STATE OF HAWAII DEPARTMENT OF TRANSPORTATION HIGHWAYS DIVISION MECHANICALLY STABILIZED EARTH RETAINING WALL (MSERW) TYPICAL SECTION AND DETAILS KAHKILI HIGHWAY WIDENING Likelike Hwy. to Vicinity of Haiku Road F.A. PROJECT NO. NH-083-1(26) SCALE: AS NOTED DATE: APRIL 1994 SHEET No. W1 OF W21 SHEETS	
--	--

AS-BUILT ADD. 114

KAHEKILI HIGHWAY WIDENING
Likelike Hwy. to Vicinity of Haiku Road
F.A. PROJECT NO. NH-083-1(26)

SECTION - CONCRETE BARRIER DETAIL

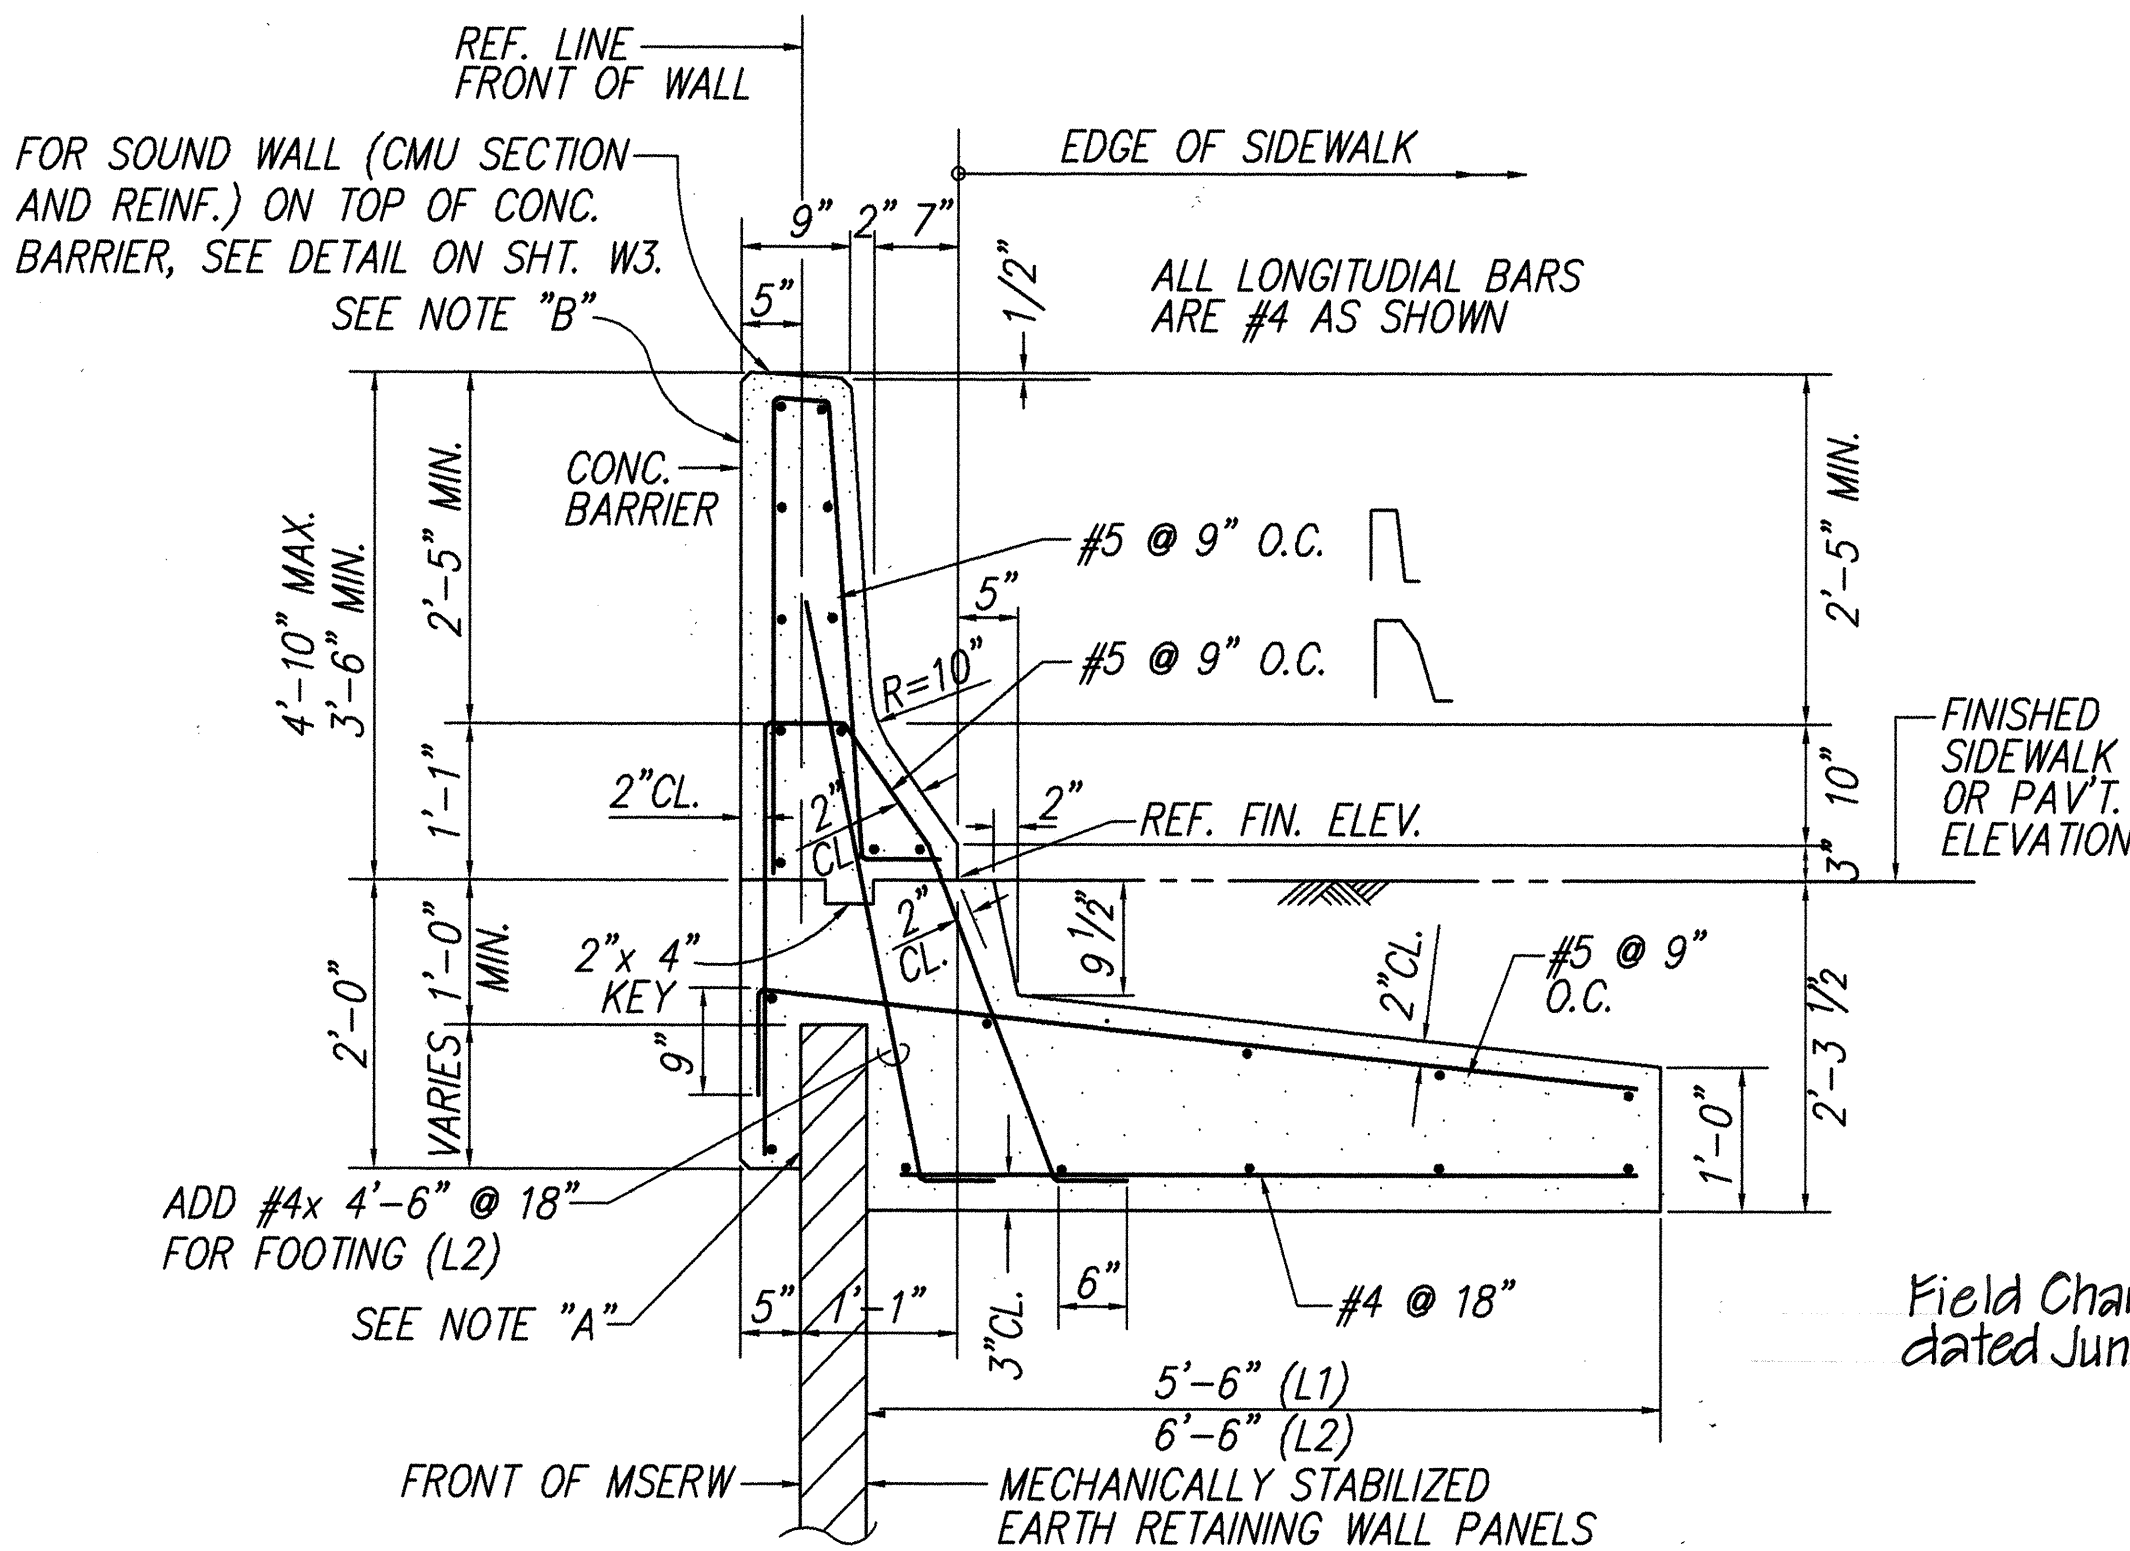
6/07/94	REVISED CONC. BARRIER DETAIL
DATE	REVISION
